Preliminary Consultation
MONTGOMERY COUNTY HISTORIC PRESERVATION COMMISSION
STAFF REPORT

Address:	10012 Menlo Ave., Silver Spring	Meeting Date:	10/9/2024
Resource:	Nominal (post-1935) Capitol View Park Historic District	Report Date:	10/2/2024
Applicant:	Alpha Houses LLC (Salem Badawy, Agent)	Public Notice:	9/25/2024
Review:	Preliminary Consultation	Staff:	Dan Bruechert
Proposal:	Partial Demolition, Two Story Addition, and Tree Removal

Figure 2: 3D rendering of the subject property with the proposed second story.

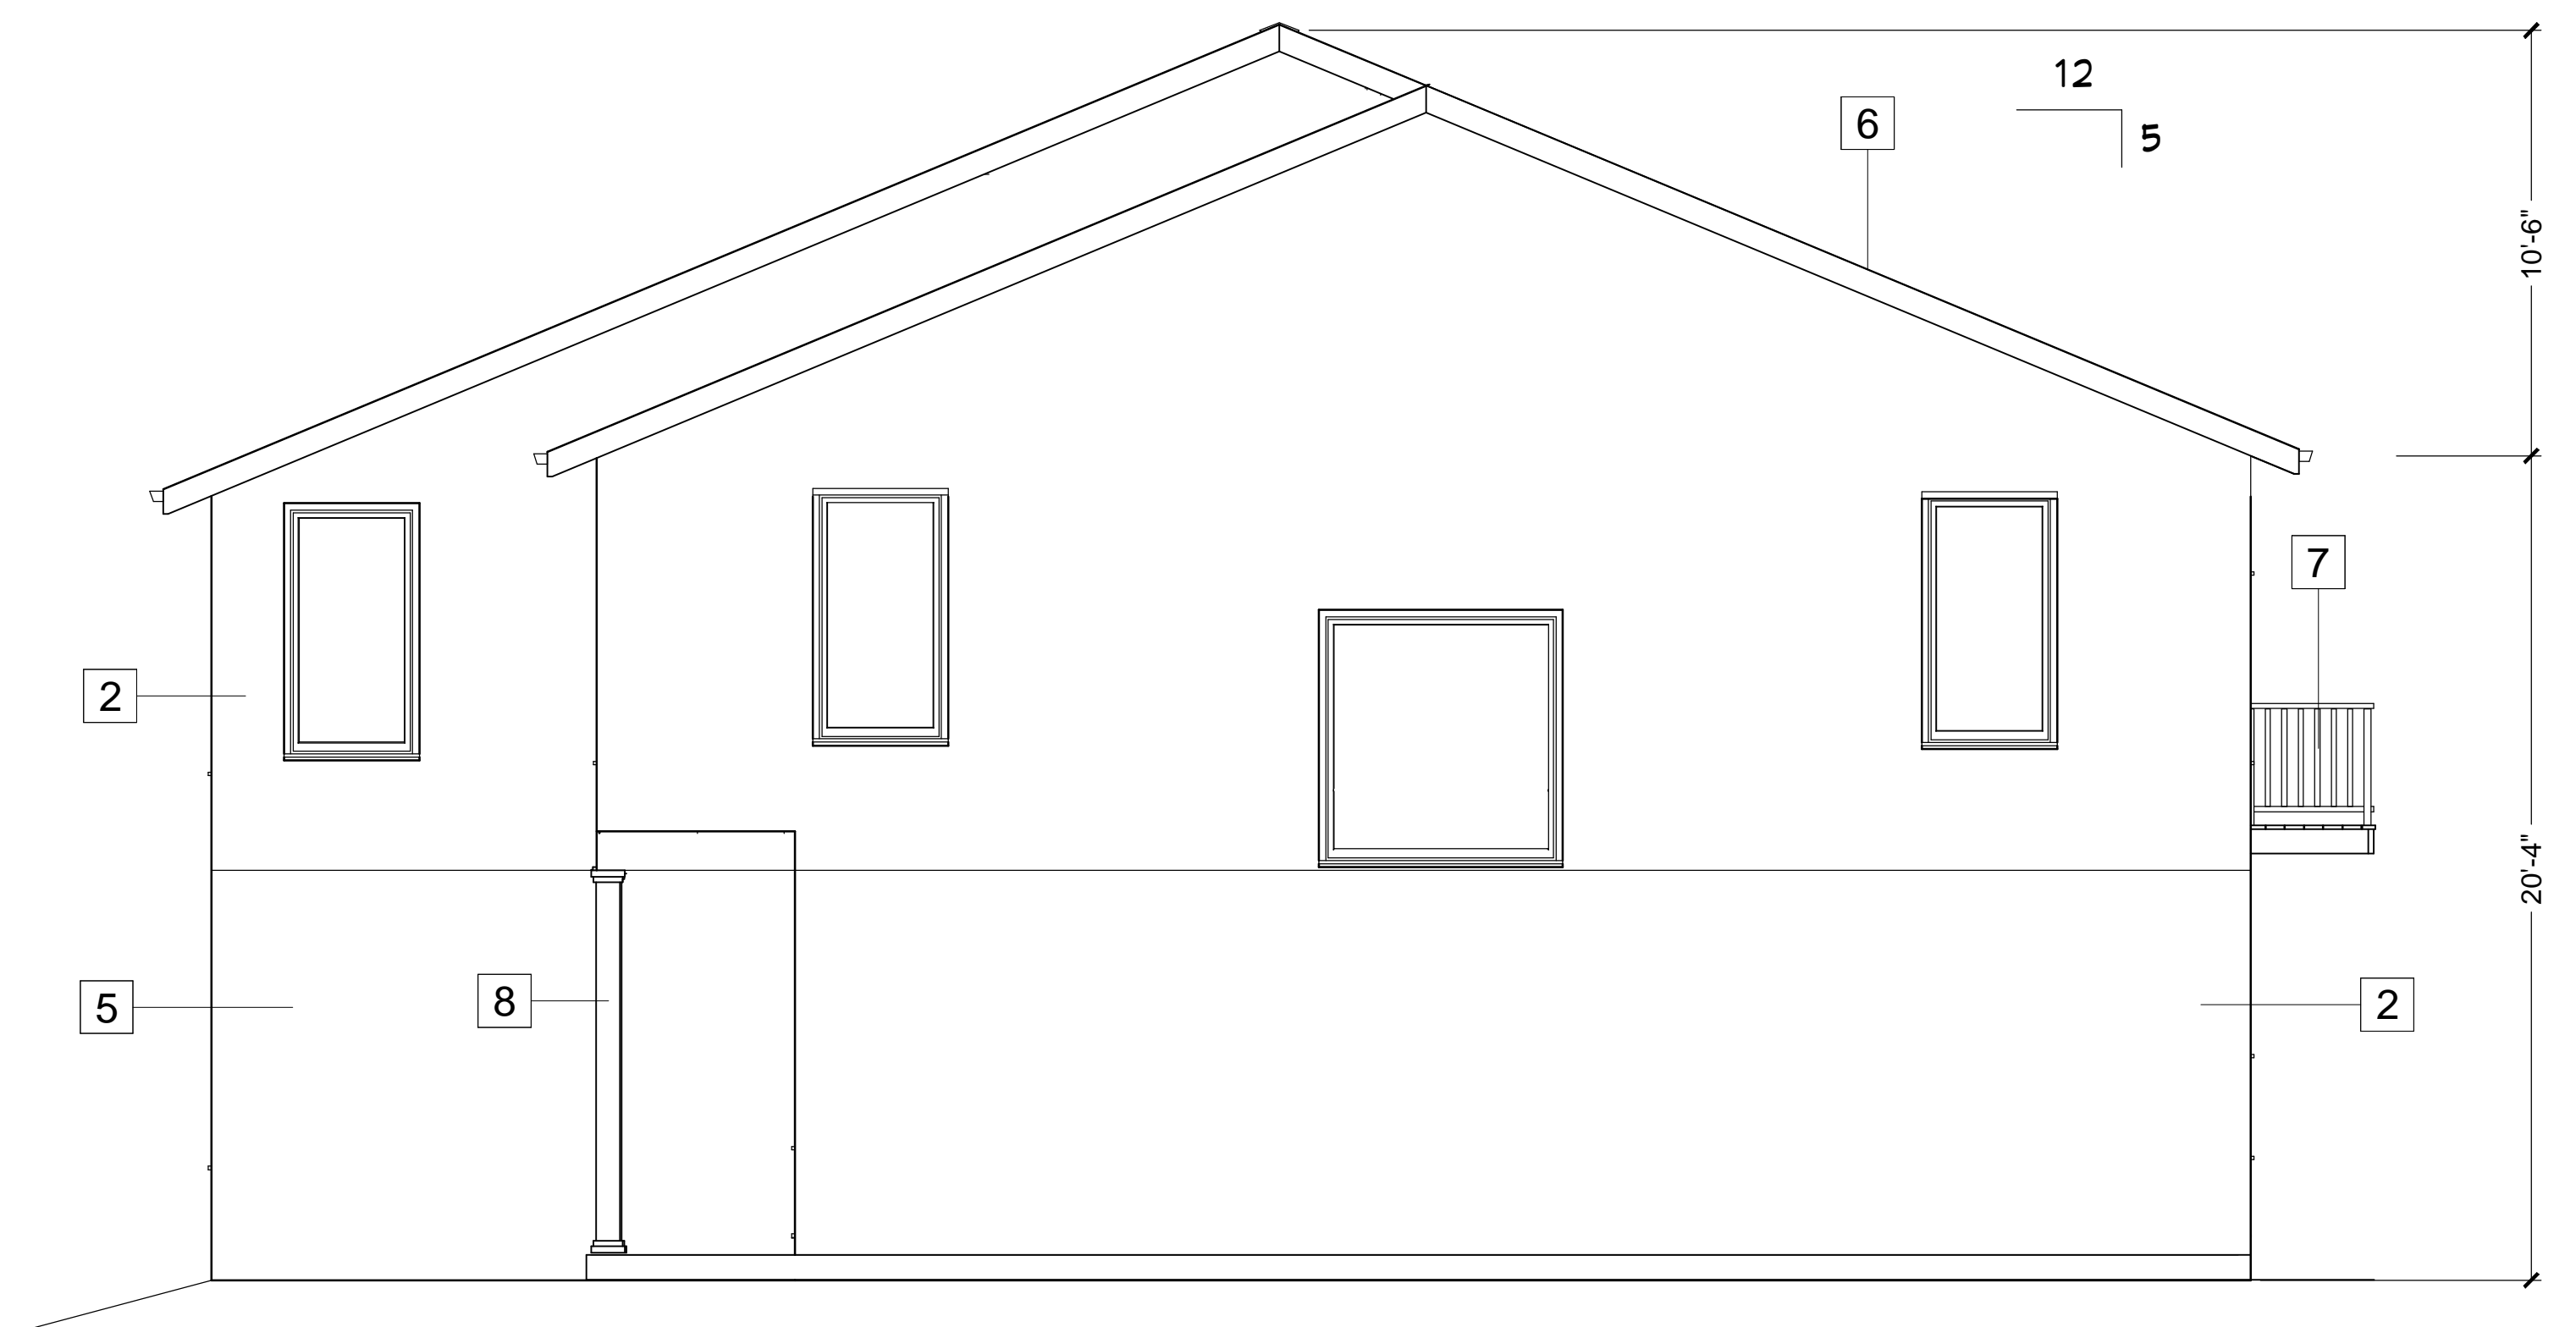
Staff finds the massing of the proposed house with its relatively simple form and two side gables is appropriate for the variety of architectural styles found throughout the Capitol View Historic District.

Staff finds the materials presented which include fiber cement panels, architectural shingles, and aluminum-clad wood windows and doors, are all appropriate for building additions and new construction in the Capitol View Park Historic District.

ELEVATIONS

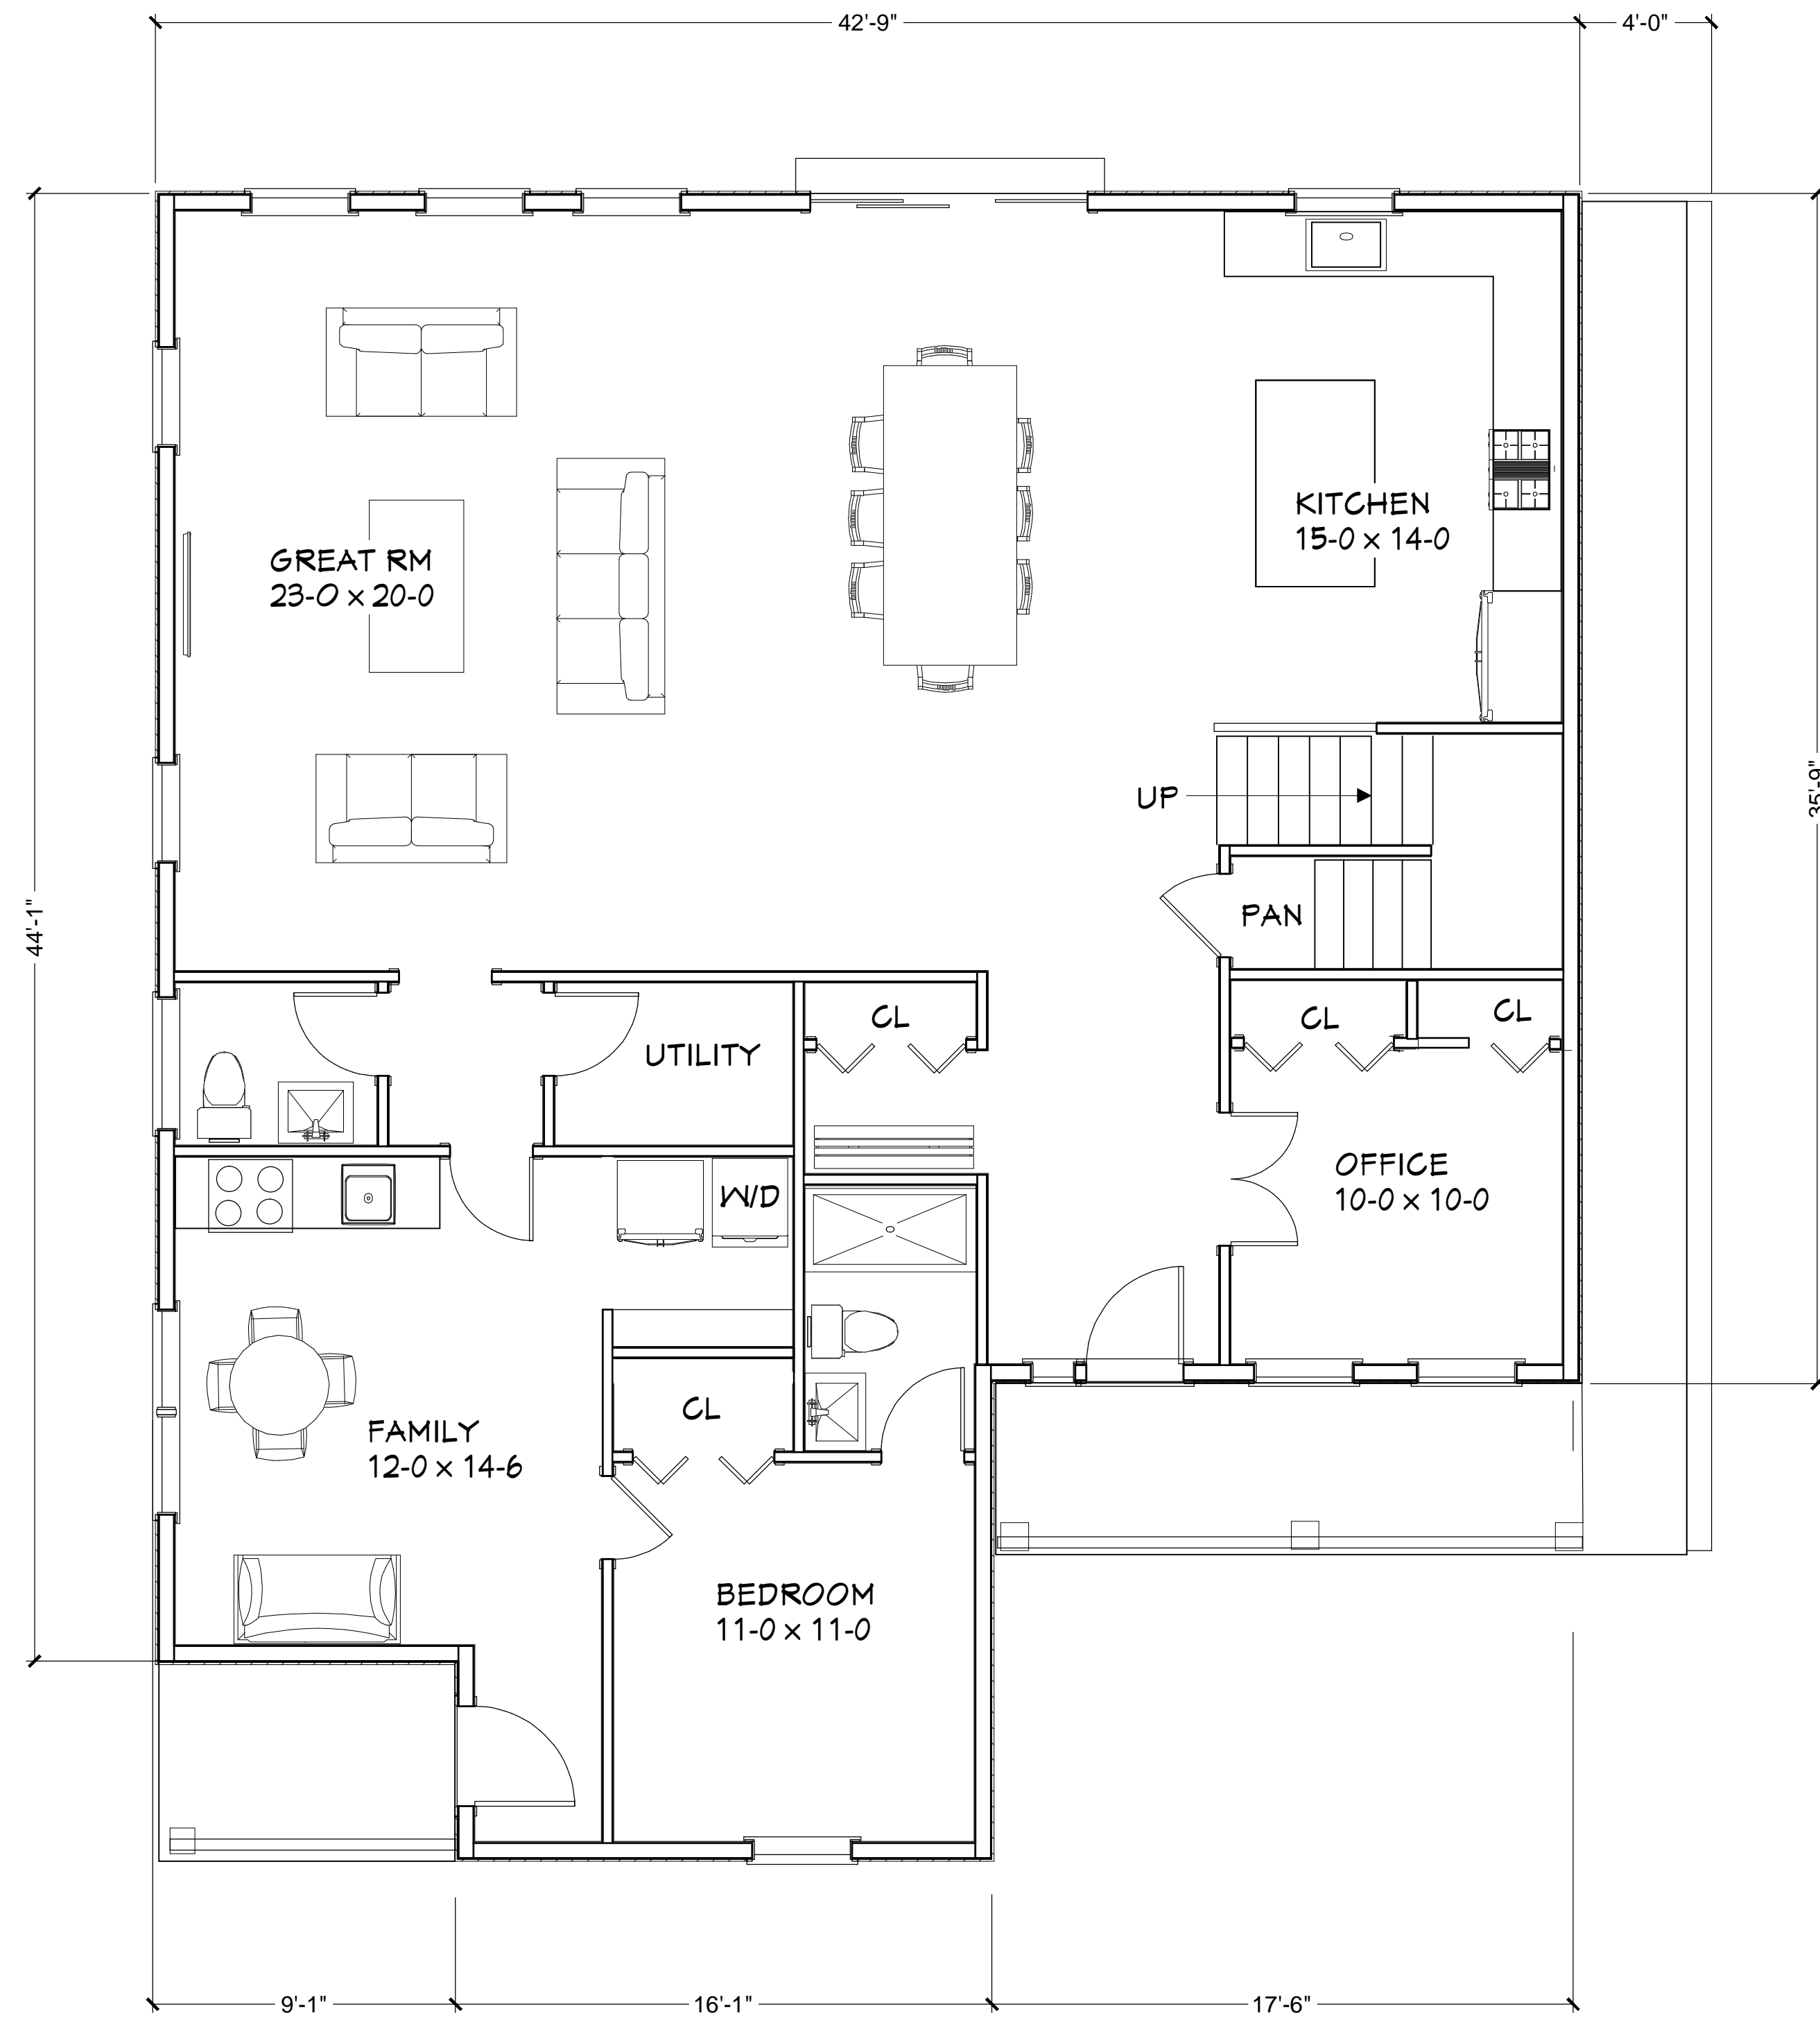
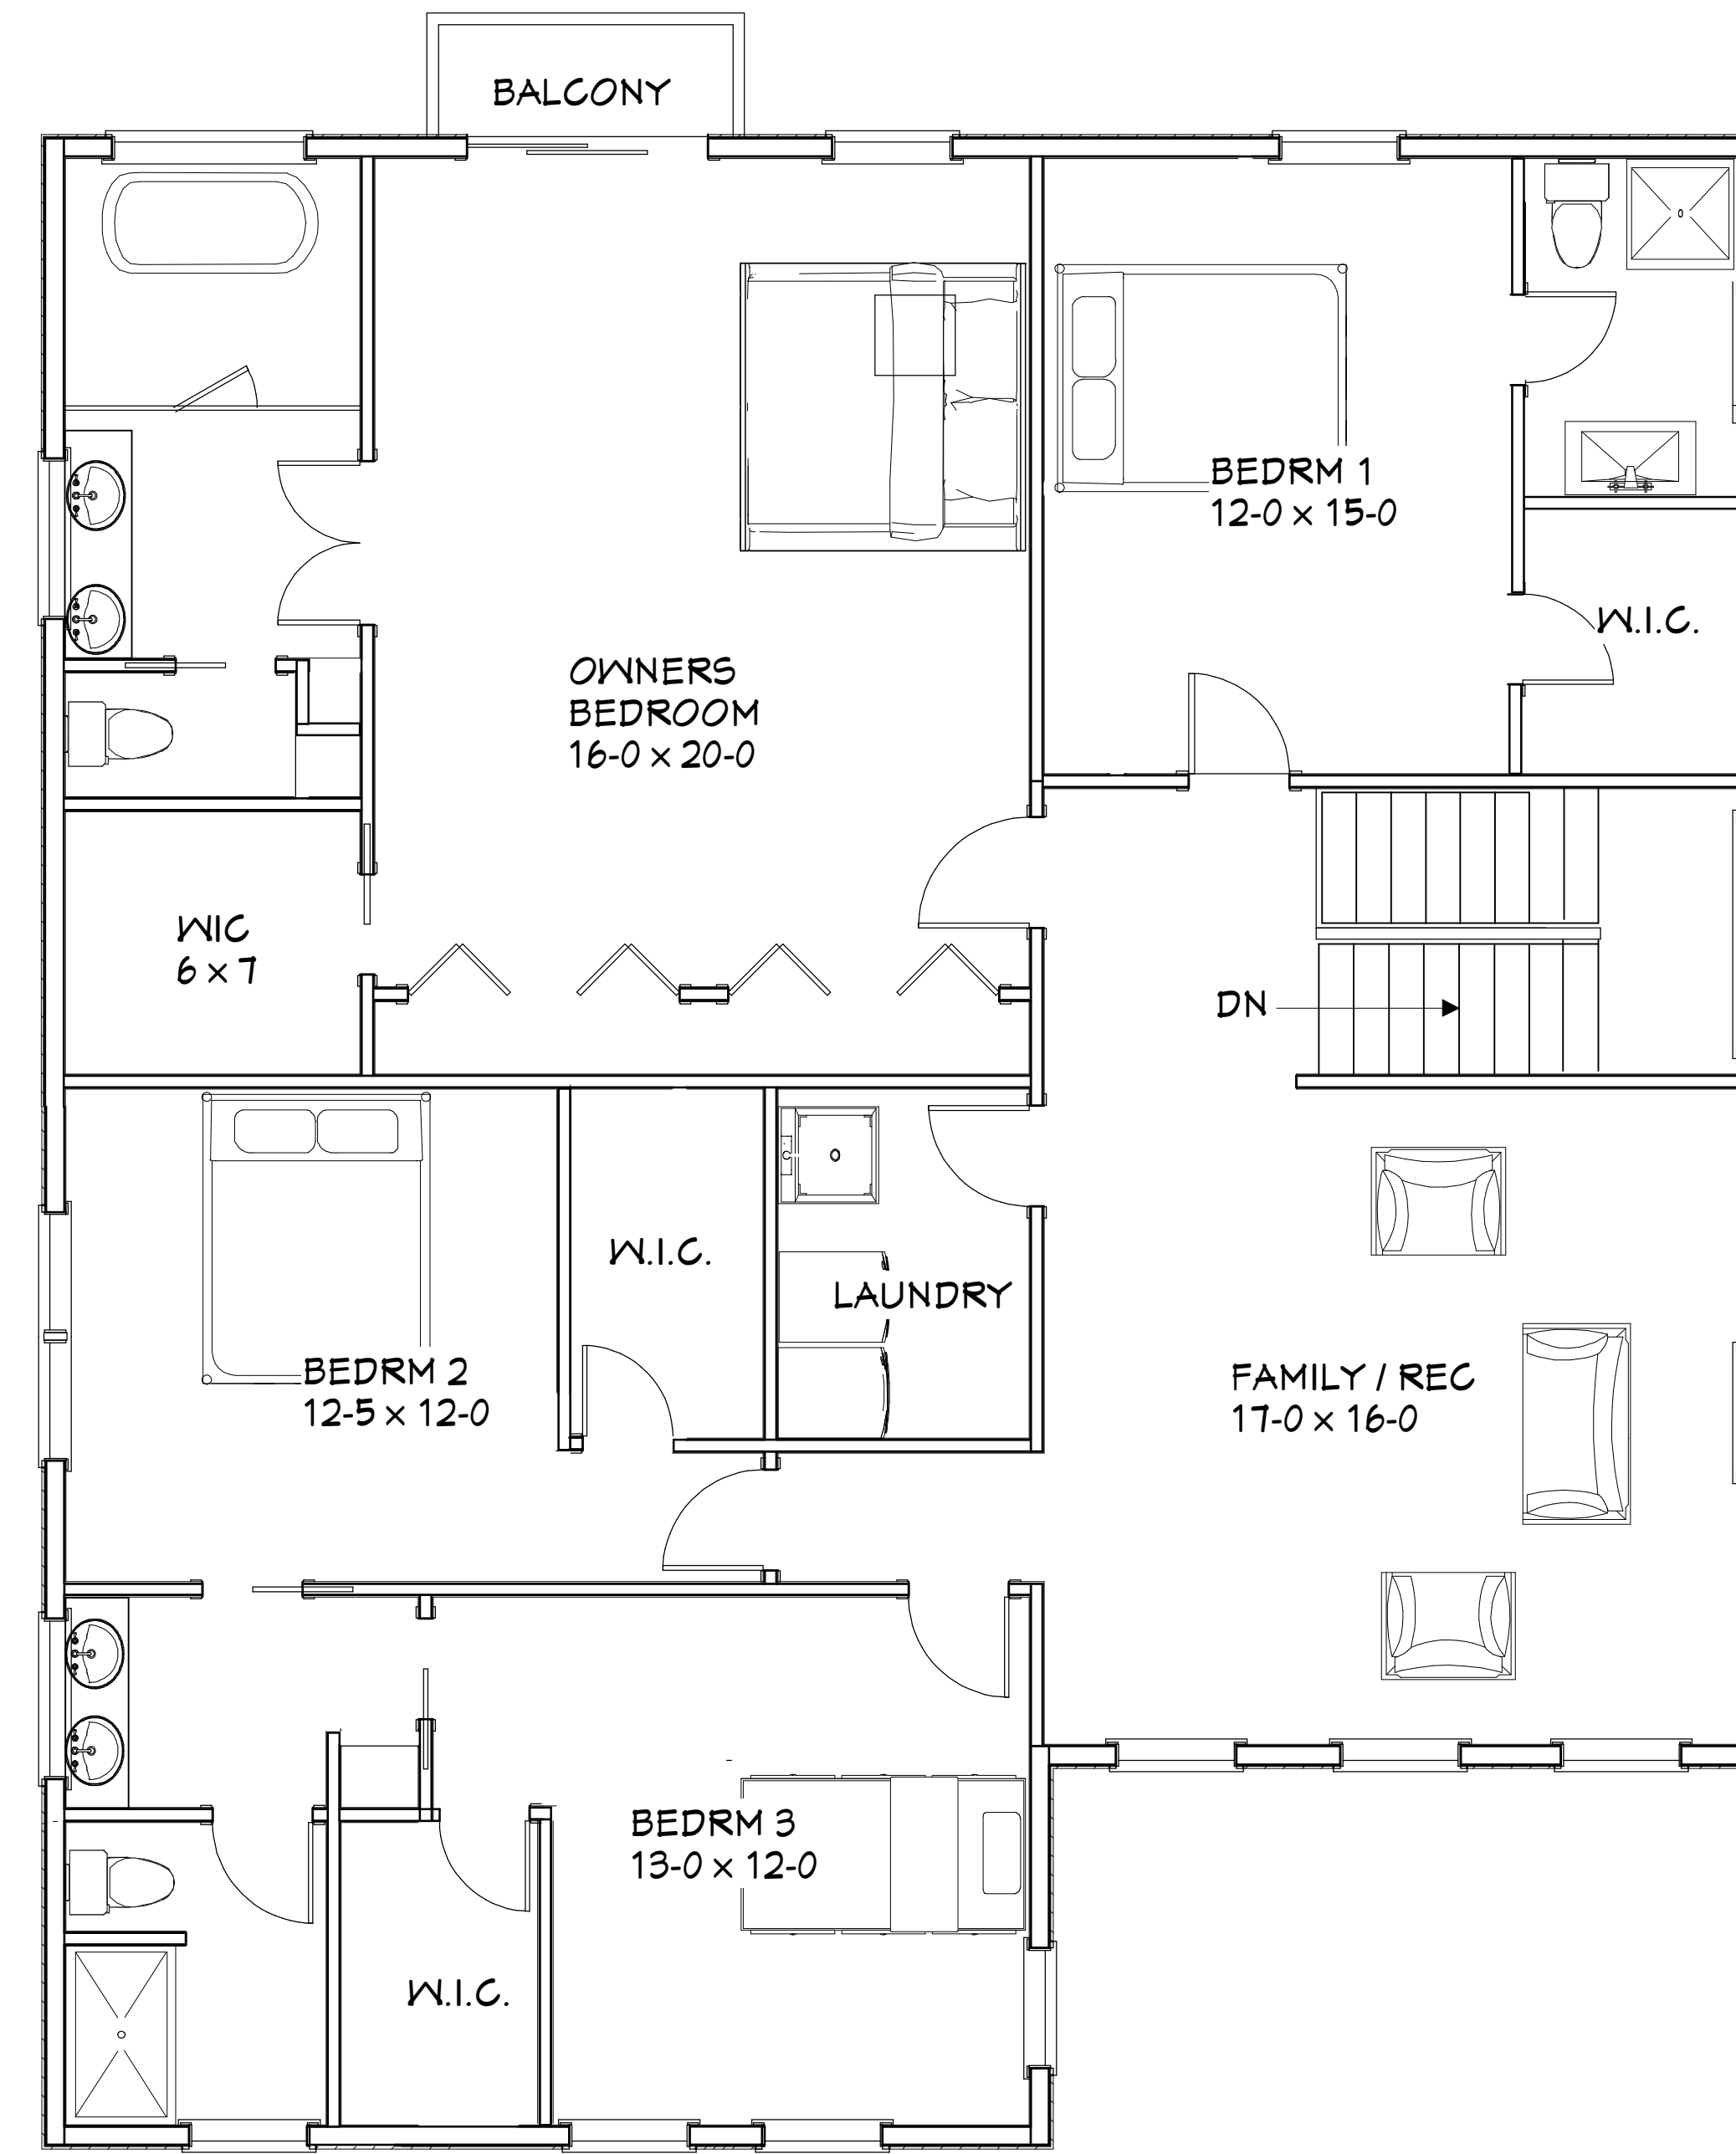
The proposed second floor has a side gable roof with Hardie panel siding, single-light aluminum-clad windows and doors, and wood columns. The contemporary design was inspired by a house in North Kensington. Staff finds the submitted drawings are not detailed enough to provide feedback on some of the architectural details, so this Staff Report will focus on an evaluation of the proposed massing and a general discussion of the proposed materials. Staff encourages the applicant to continue to work with Staff as plans are further refined prior to a HAWP submission.

- Drawings of the existing building;
- Detailed elevation and plan drawings of the proposed house with a sufficient level of detail to effectively evaluate the proposed work;
- Any renderings should be shown without trees as the HPC is charged to evaluate proposals in the absence of vegetation;
- An existing site plan with tree location, size, and species identified;
- All specification materials;
- Complete materials for the fence and hardscaping including locations on a scaled site plan and all material specifications and images;
- A detailed proposed site plan that includes the location of any alterations to the hardscaping and includes details for the dimension and appearance of any new hardscaping/significant re-grading;
